## **DEVELOPMENT REVIEW COMMITTEE MEETING AGENDA**

DRC Meeting Draft Minutes  
Holden Avenue Planned Development  
August 10, 2021, at 11:00 am

**To:** Development Review Committee  
**From:** Brett Sollazzo, Deputy City Clerk  
**Date:** January 31, 2022  
**Re:** Haven Oaks Proposed Planned Development

Project: Haven Oaks Development Plan/Preliminary Subdivision Plan

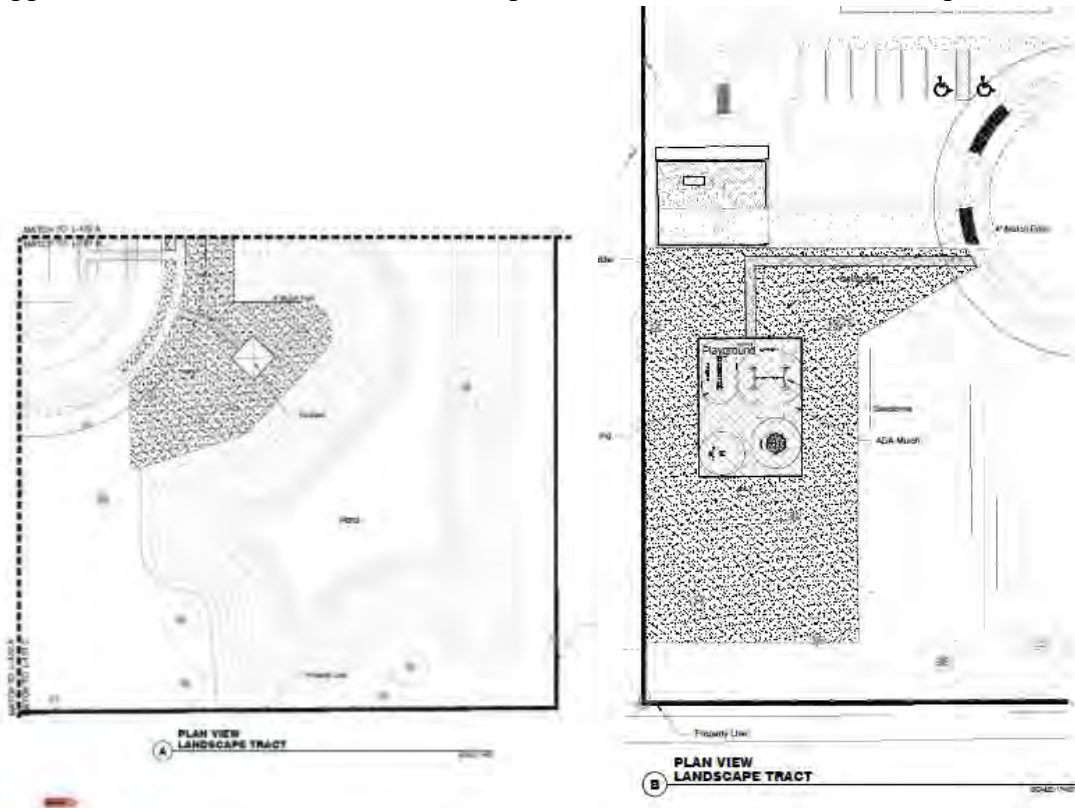
14. Please use darker lines to delineate the lots and tract boundaries. For example, Tract F, the recreation tract appears to include the area south of Lots 22-25. If this is the case, is that area really being used for recreation?

**WALL SECTION**  
N.T.S.

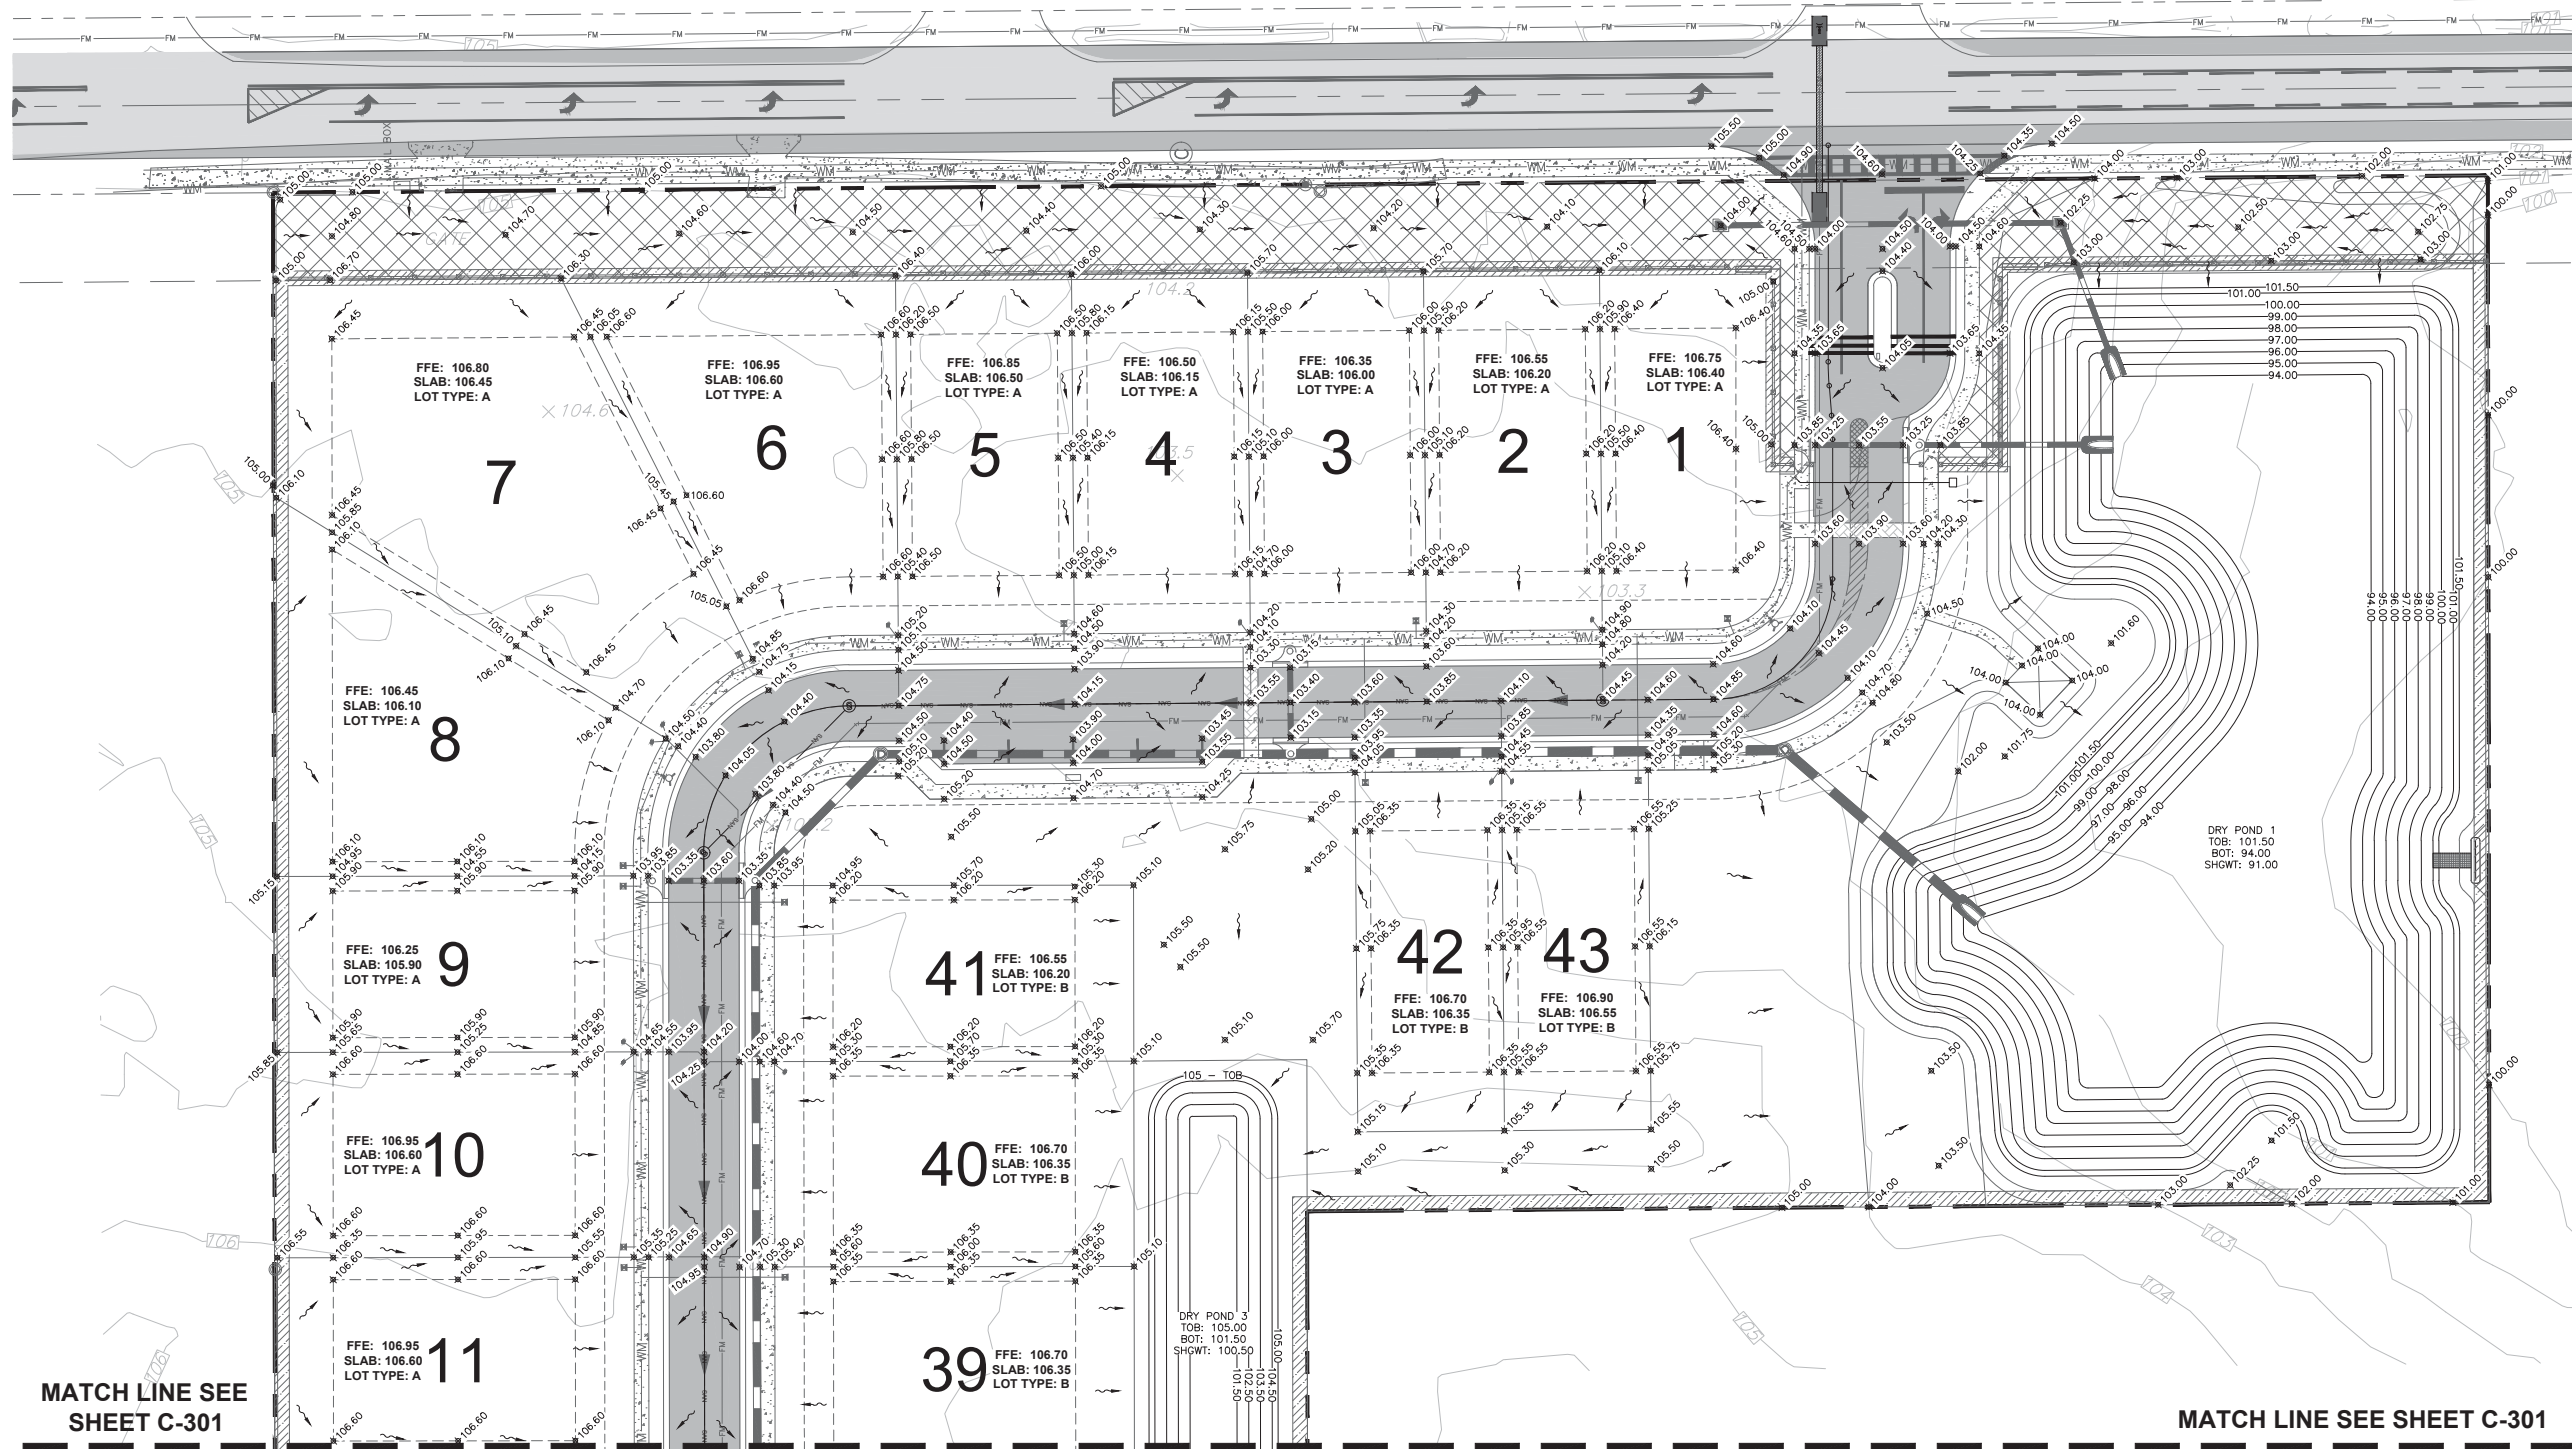
50. Sheet C-001 – Fire Note #9 – does this note apply to this project? Where is the proposed Hose House? Revise accordingly.
51. Sheet C-302 – For Typical Wall Section, how will Pond #3 discharge if the wall is imbedded in the ground and the ground is sloped back towards the pond? Also need to see this info in the storm calculations to verify the pond stage/discharge.

52. Sheet C-302 – How will Pond #2 discharge if the wall extends all along the west property line?
53. Sheet C-303 – missing call out for outfall structure for Pond #2. Same for Pond #1 on sheet C-302.
